Development Facilitation Team (DFT) – Review Comments

Project No: PR-2020-004024

Request: Create 4 new lots from 3 existing lots, vacate a portion of single Easement [20], and Grant Public Utility Easement.

Application For: SD-2024-00074 – PRELIMINARY/FINAL/PLAT (DHO)

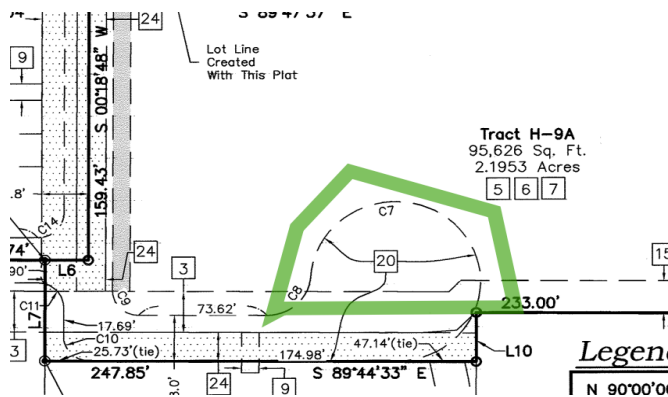
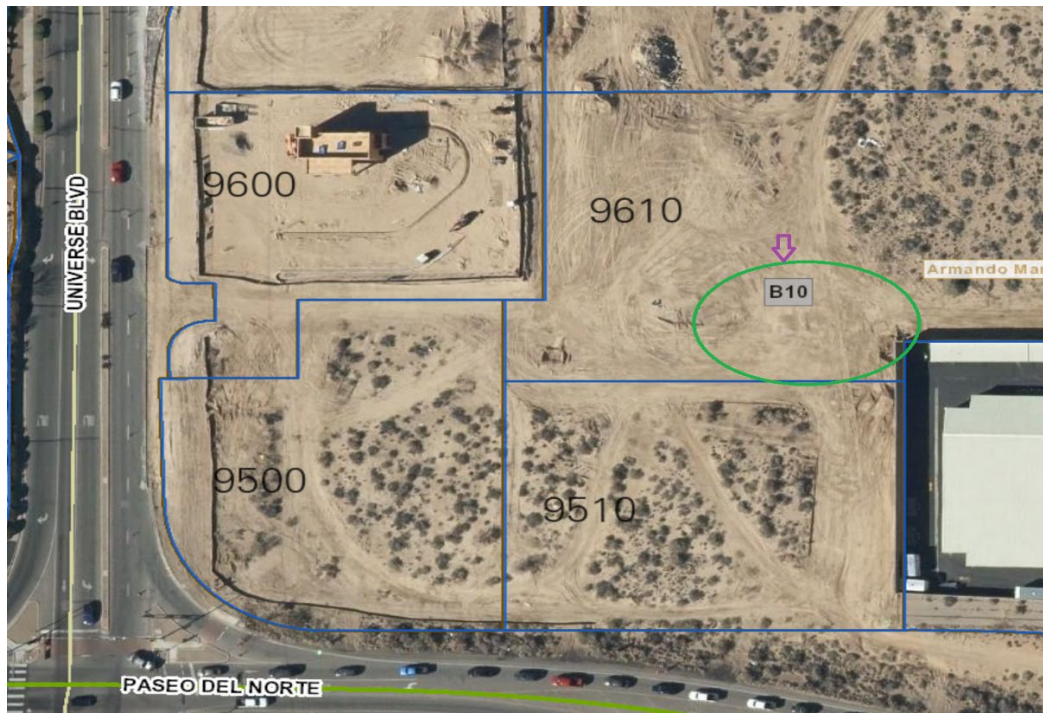
- The applicant proposes to vacate a portion of the private easement as marked in green in the above images.
 - Planning staff defers to **Transportation** regarding the compliance of the vacation of this private easement **per the DPM and IDO and the justification of its partial Vacation per 6-6(M)(3) of the IDO.**
